The Town of Hilton Head Island Regular Design Review Board Meeting

Tuesday, July 27, 2010

DESIGN TEAM/ DRB COMMENT SHEET

PROJECT South Island PSD

PHASE I ADDITIONS/MODIFICATIONS
SITE PLAN

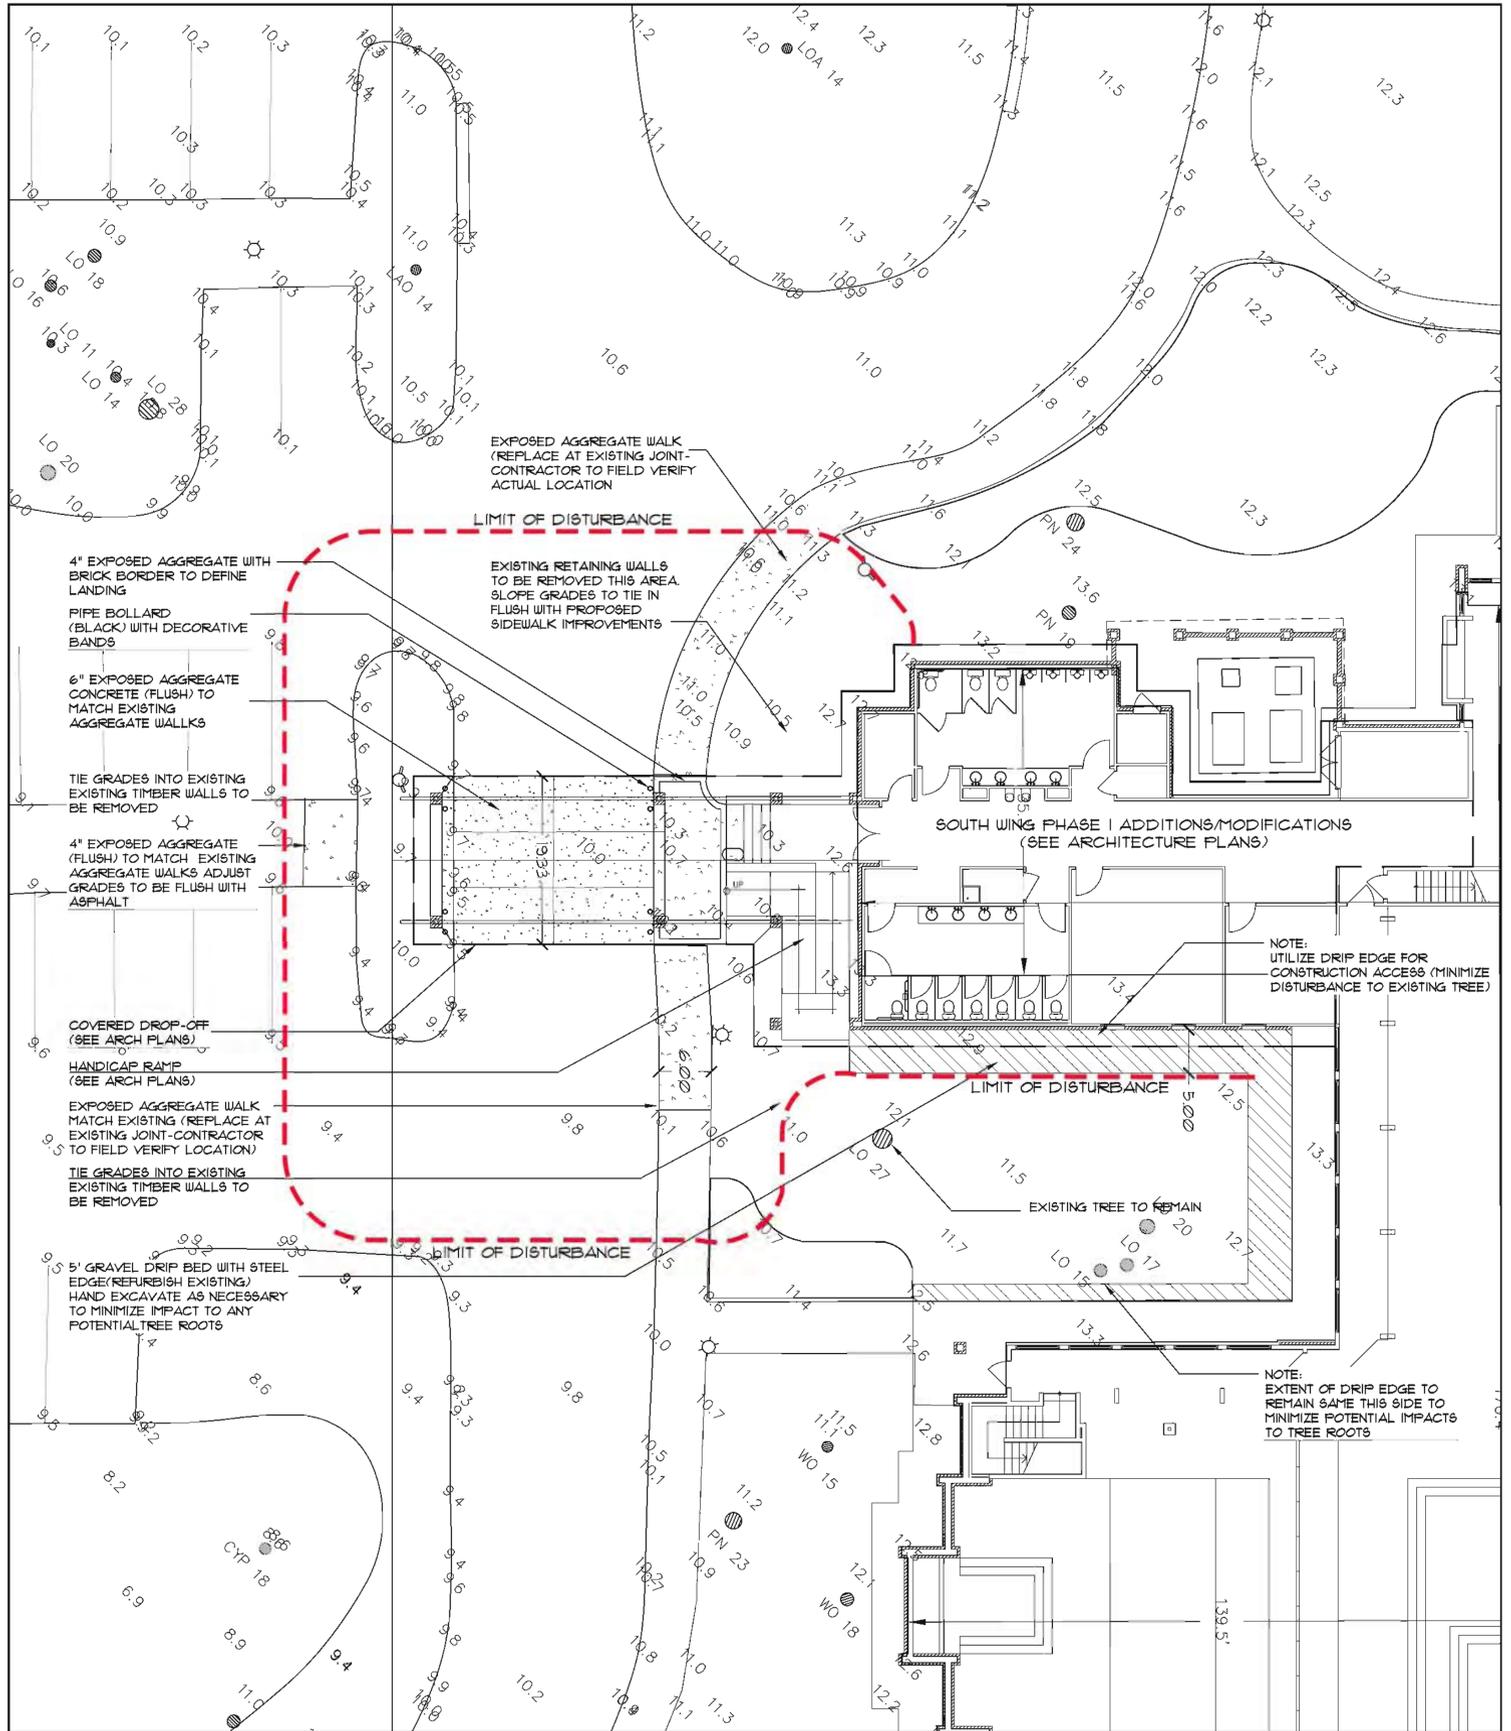
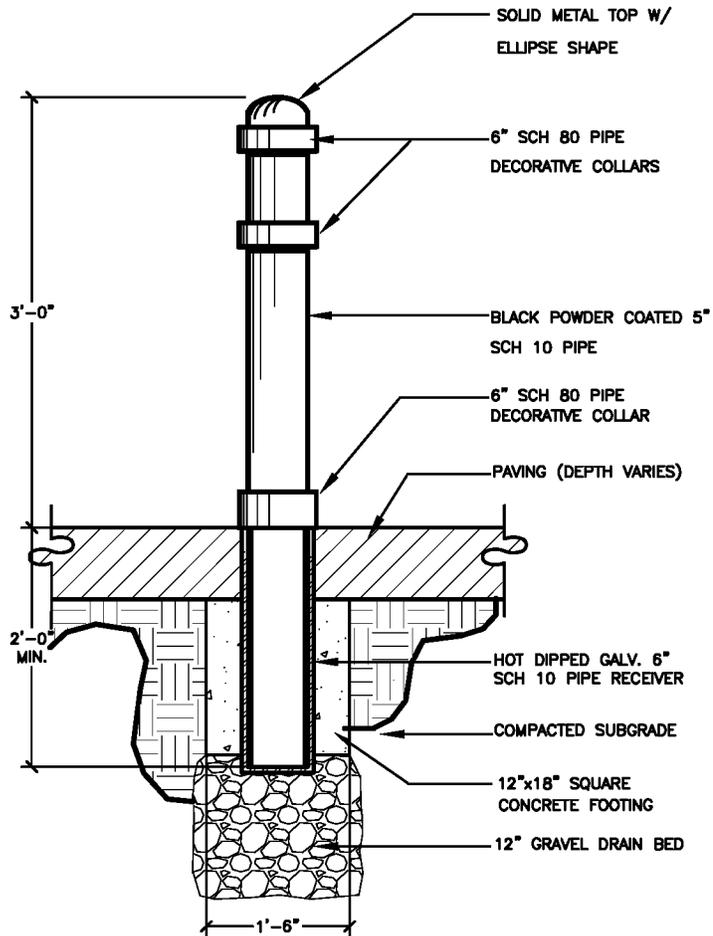
DESIGN GUIDE/LMO CRITERIA	COMPLIES YES/NO/NA	COMMENTS OR CONDITIONS
An effort has been made to preserve existing trees and under story plants		To decrease impacts to root system of 27 inch live oak, remove three RODH nearest tree.
Supplemental and replacement trees meet LMO requirements for size, species and number		
Wetlands if present are avoided and the required buffers are maintained		
Sand dunes if present are not disturbed

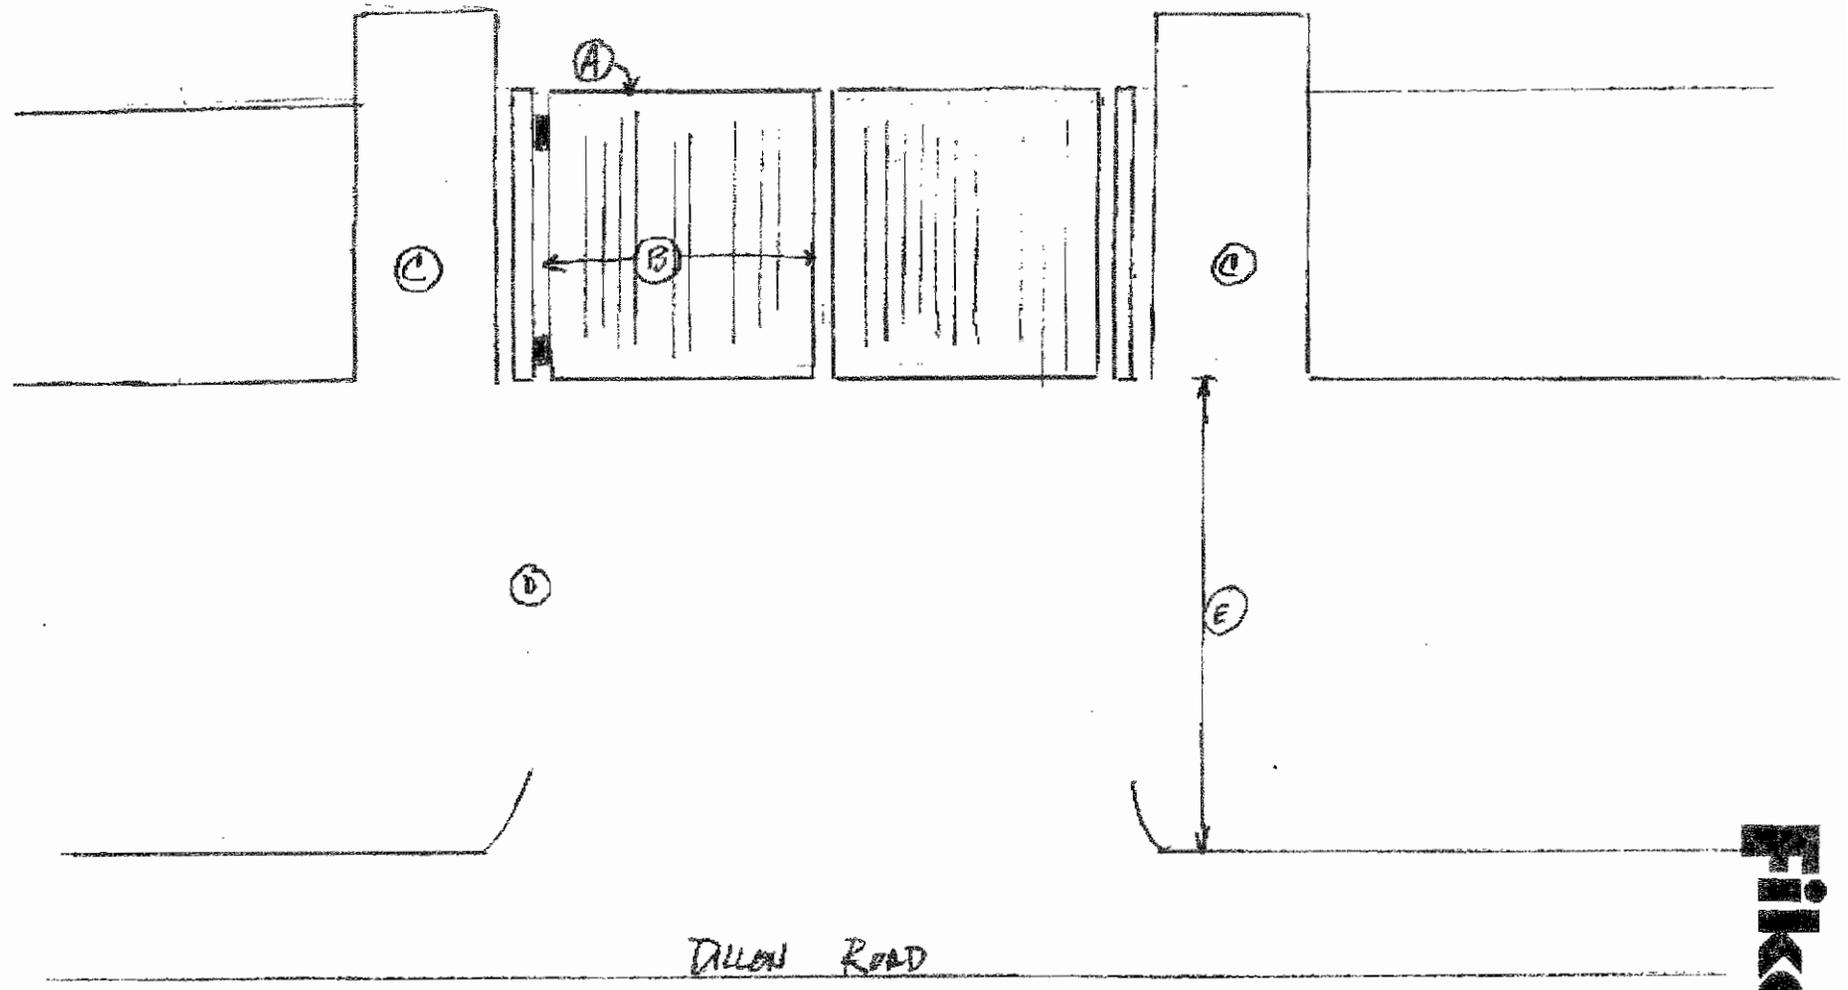
ARCHITECTURAL DESIGN- Staff would like to see more detail of a photo of the proposed pipe-mount. Staff would also like to see a cut sheet of photo of a matching key pad system		
DESIGN GUIDE/LMO CRITERIA	COMPLIES YES/NO/N/A	COMMENTS OR CONDITIONS
Structure is designed to be appropriate to the neighborhood		
Promotes pedestrian scale and circulation		
Design is unobtrusive and set into the natural environment		
Utilizes natural materials and colors		
Avoids distinctive vernacular styles		
Design is appropriate for its use		
All facades are have equal design characteristics		
Avoids monotonous planes or unrelieved repetition		
Has a strong roof form with enough variety to provide visual interest		
Minimum roof pitch of 6/12		
Overhangs are sufficient for the façade height.		
Forms an details are sufficient to reduce the mass of the structure		
Human scale is achieved by the use of proper proportions and architectural elements
